# MANDATORY REFERRAL NO. MR2025022

## PINEY BRANCH ROAD BIKEWAY

This is a Mandatory Referral for the Montgomery County Department of Transportation proposal for separated bike lanes along Piney Branch Road. The project has two segments: between Sligo Creek Parkway and Greenwood Road, and between University Boulevard and New Hampshire Avenue. The proposed separated bike lanes connect to the striped bike lanes being built as part of the Purple Line transit project between Greenwood Road and University Boulevard.

MCPB ITEM NO. 09

Figure 8: Piney Branch Road at Manchester Road Bicyclist Movements

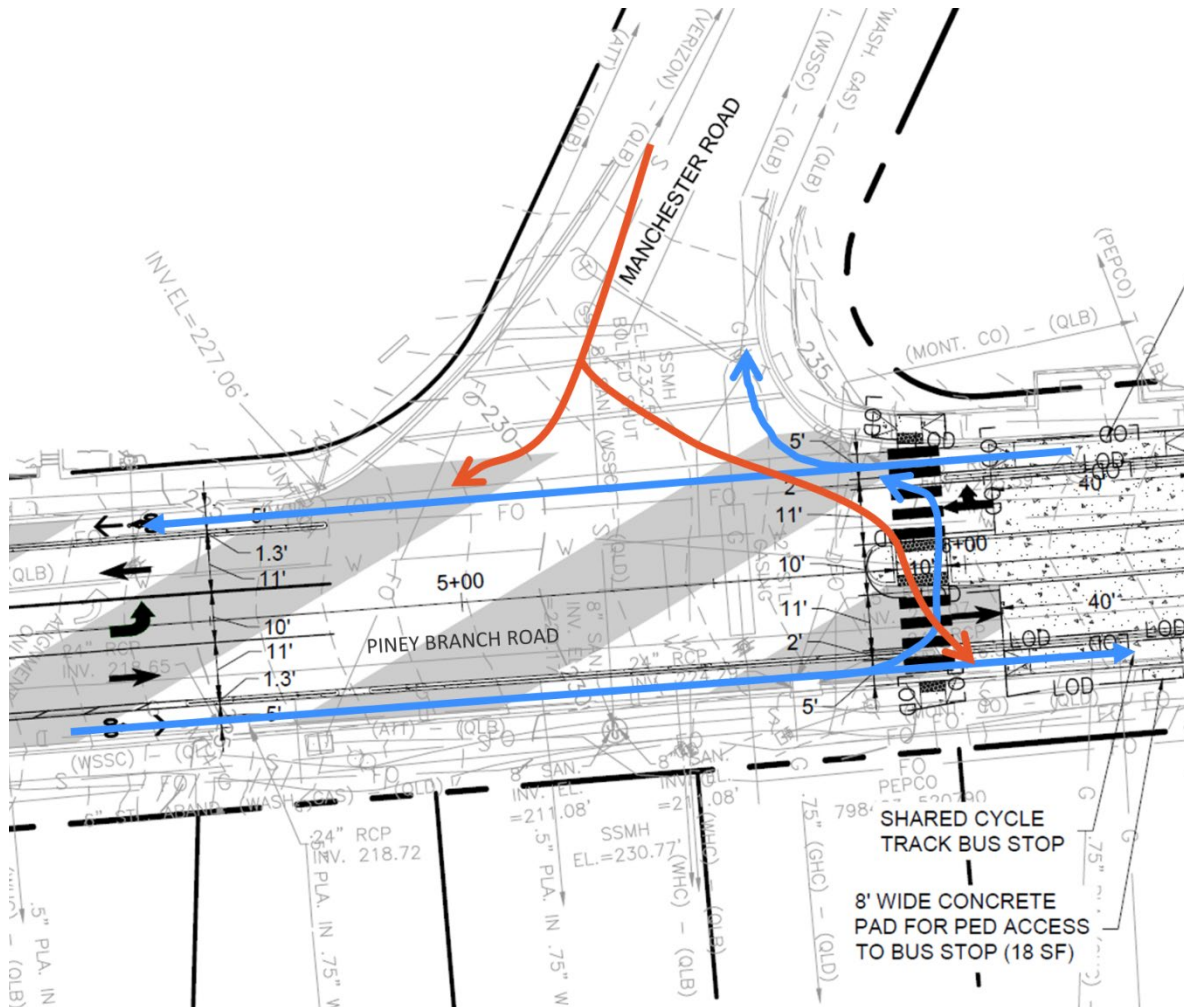
**Recommendation: Redesign the intersection of Piney Branch Road and Manchester Road to:**

- Provide a protected crossing of Piney Branch Road**  
 The distance between the protected crossing locations at Sligo Creek Parkway and Flower Avenue is 1,100 feet, which is longer than the Town Center Boulevard maximum 400-foot protected crossing spacing. Providing a protected crossing at this location would serve bus riders boarding and alighting from stops at this intersection, make it safer for pedestrians and bicyclists to cross the street, and shorten the maximum protected crossing spacing to 660 feet.
- Improve how bicyclists travel between Manchester Road and the eastbound Piney Branch Road bike lanes**  
 The current bikeway design through this intersection does not allow bicyclists to intuitively

travel between southbound Manchester Road and the eastbound Piney Branch Road bikeway as shown in Figure 8. Red arrows in the figure indicate how Manchester Road bicyclists can travel east and west on Piney Branch Road. Bicyclists from Manchester Road intending to continue eastbound onto Piney Branch Road must travel against traffic to enter the crosswalk because there are no other breaks in the separated bike lane barrier. Some type of break in the eastbound bikeway concrete barrier should be considered at a location that makes logical sense for Manchester Road bicyclists to enter. Blue lines in the figure illustrate Piney Branch Road bicyclist travel paths.

Figure 9: Bike Lane Buffer along University Boulevard

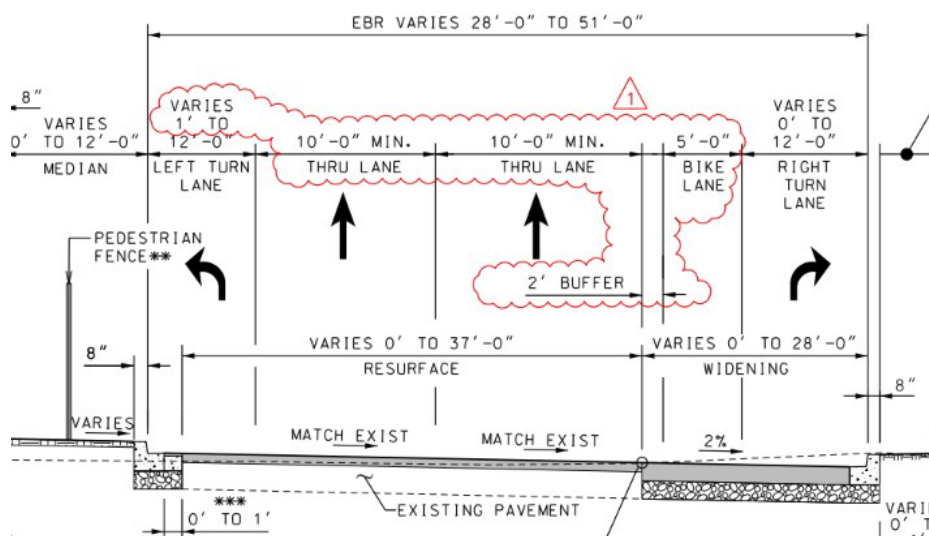
**Recommendation: Work with MDOT to add a flexpost buffer to the striped bike lanes that are to be constructed by the Purple Line project between Greenwood Avenue and University Boulevard by narrowing the motor vehicle travel lanes.**

When the Purple Line corridor was designed, support for separated bike lanes was not as widespread as it is today. The Purple Line project's decision on Piney Branch Road and other roadways to construct striped bike lanes reflects this. Today, with separated bike lanes the standard, there have

been changes to the design of some bike lanes along the Purple Line route, notably on University Boulevard, to include a buffer between the bike lanes and motor vehicle lanes, as shown in Figure 9. The MCDOT project team should consider coordinating with the Purple Line project team to see if similar buffers can be implemented along Piney Branch Road.

*Figure 11: Tighter Curb Radii Visibility Illustration*

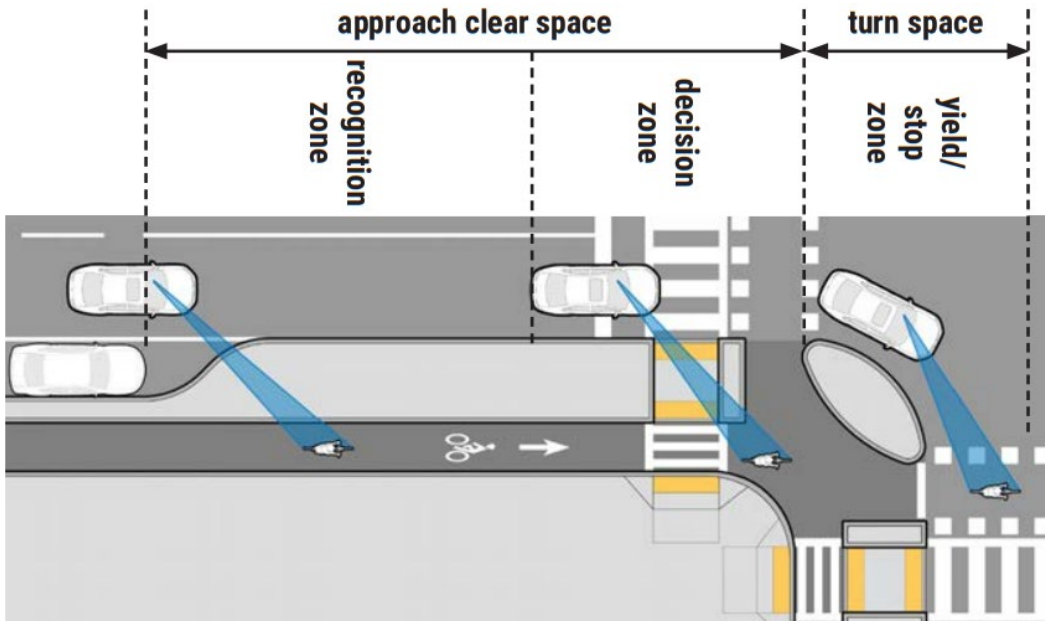
Additionally, the smaller the curb radius, the less roadway pedestrians have to cross, reducing their exposure to conflict.

Figure 12: Potential Curb Radii Changes at Nob Hill Apartments Driveway

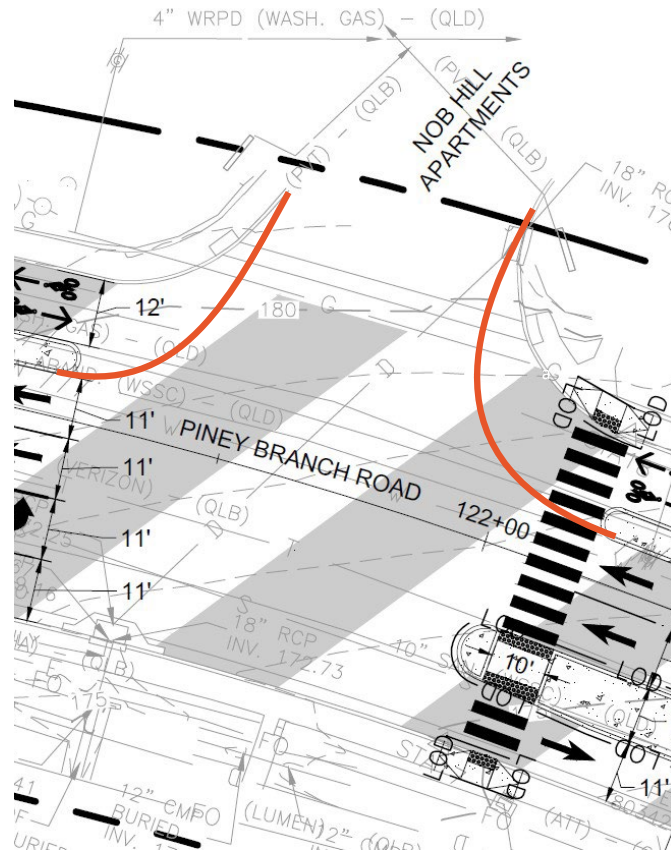
Figure 12 illustrates potential curb radii changes at the Nob Hill Apartments driveway (122+00). Similar improvements should be considered at the following locations:

- Manchester Road Intersection (5+00)
- Pineway Towers Driveway (106+50)
- Forest Park Apartments (128+00)

Figure 14: Conflict Point at Shopping Complex Access

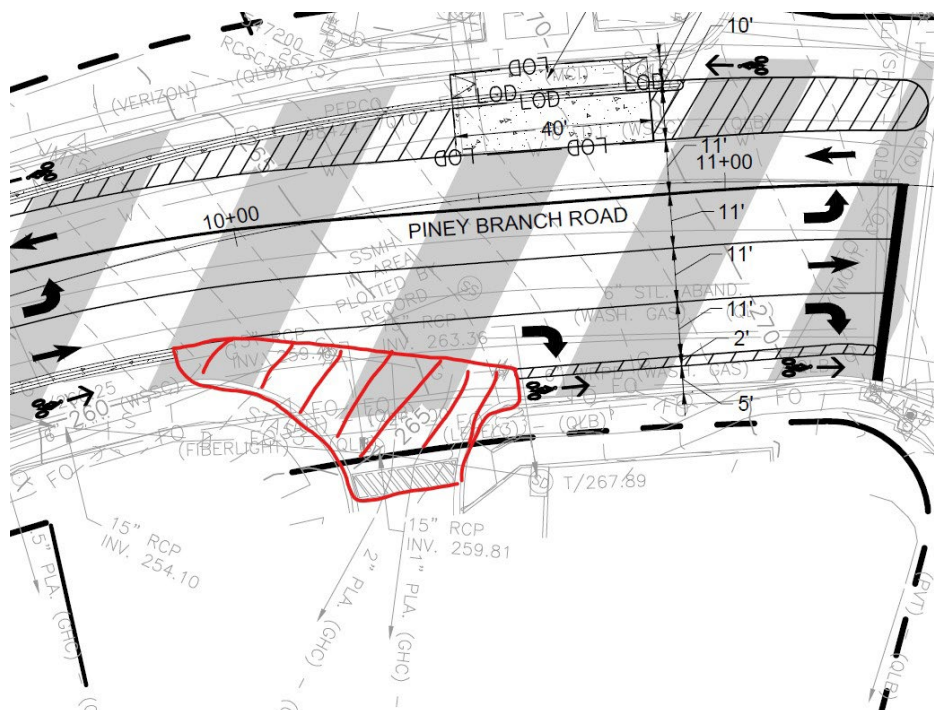
**Recommendation: Redesign site access to the shopping complex at the southwest corner of Piney Branch Road at Flower Avenue to improve visibility and safety for all road users.**

The curbline in front of this shopping complex is set back further than the curbline to the west. This setback, combined with the building shown in Figure 13, creates a likely sight distance issue for drivers exiting from this driveway. It may be difficult for them to see people biking from their left (towards the viewer in Figure 13). To reduce the sight distance issue and encourage drivers to check for people biking, two options should be considered.

1. Left turns from this driveway could be prohibited. As shown in Figure 14, turning left at this location will require crossing three travel lanes into a fourth while tracking traffic in both directions. Prohibiting this movement will allow drivers to focus on only one direction of vehicular and bicycle traffic, reducing the likelihood that they miscalculate traffic gaps and cause a crash.
2. The majority of the red hatched area in Figure 14 could be raised to sidewalk level and have green conflict markings to make clear to drivers that this is an area where they should expect bicyclists. Raising this area and providing conflict markings should also reduce the frequency of drivers inching out into the bike lane to look for gaps in traffic.
